8. Well Name and No.  
TRISTE DRAW 25 FEDERAL COM 13H9. API Well No.  
30-025-44001-00-X110. Field and Pool or Exploratory Area  
TRISTE DRAW-BONE SPRING11. County or Parish, State  
LEA COUNTY, NM**SUBMIT IN TRIPLICATE - Other instructions on page 2**

Cimarex respectfully request approval for a multibowl well head, please see attached diagram and procedure.

**Multibowl Wellhead**  
**Conditions of Approval**  
**Triste Draw 25 Fed Com 13H**

**Cactus Multi-Bowl Wellhead Steps:**

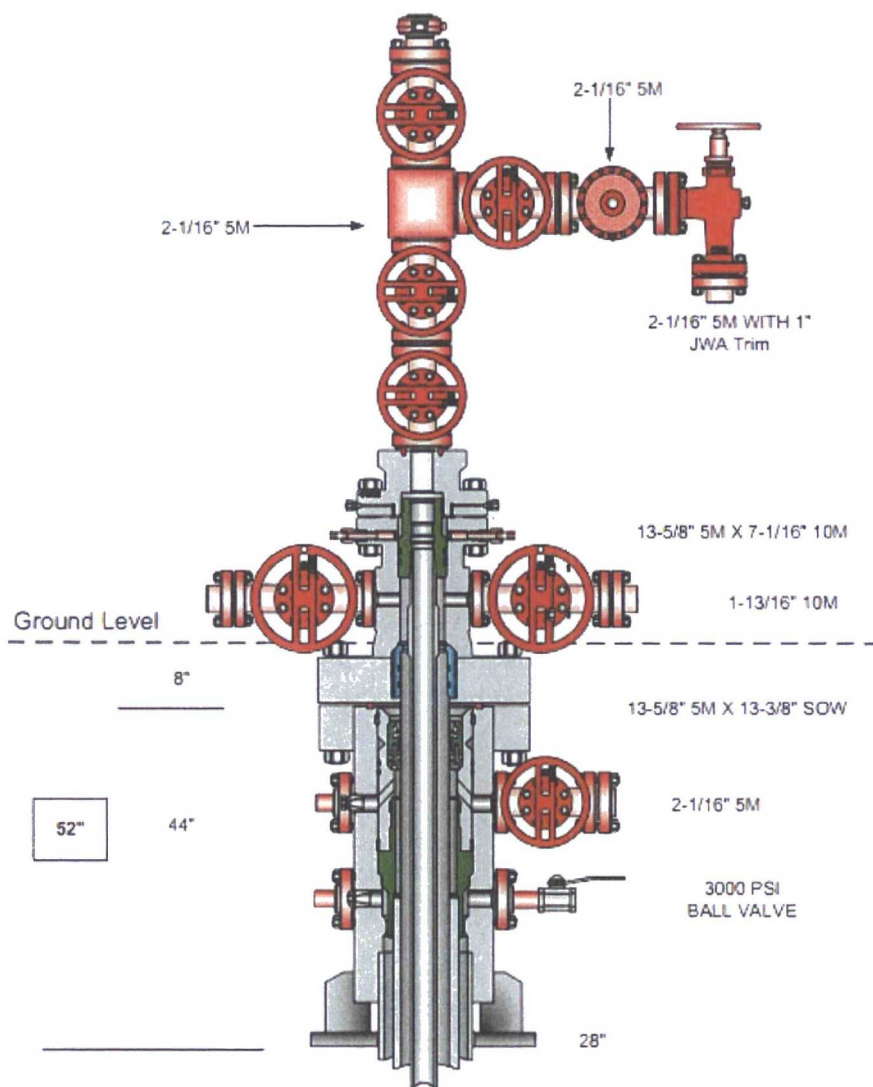
\*\* BLM REVISED \*\* BLM REVISED \*\* BLM REVISED \*\* BLM REVISED \*\* BLM REVISED \*\*

3. Operator has proposed a multi-bowl wellhead assembly. This assembly will only be tested when installed on the surface casing. Minimum working pressure of the blowout preventer (BOP) and related equipment (BOPE) required for drilling below the surface casing shoe shall be 3000 (3M) psi.

- a. Wellhead shall be installed by manufacturer's representatives, submit documentation with subsequent sundry.
  - b. If the welding is performed by a third party, the manufacturer's representative shall monitor the temperature to verify that it does not exceed the maximum temperature of the seal.

- c. Manufacturer representative shall install the test plug for the initial BOP test.
  - d. Operator shall perform the intermediate casing integrity test to 70% of the casing burst. This will test the multi-bowl seals.
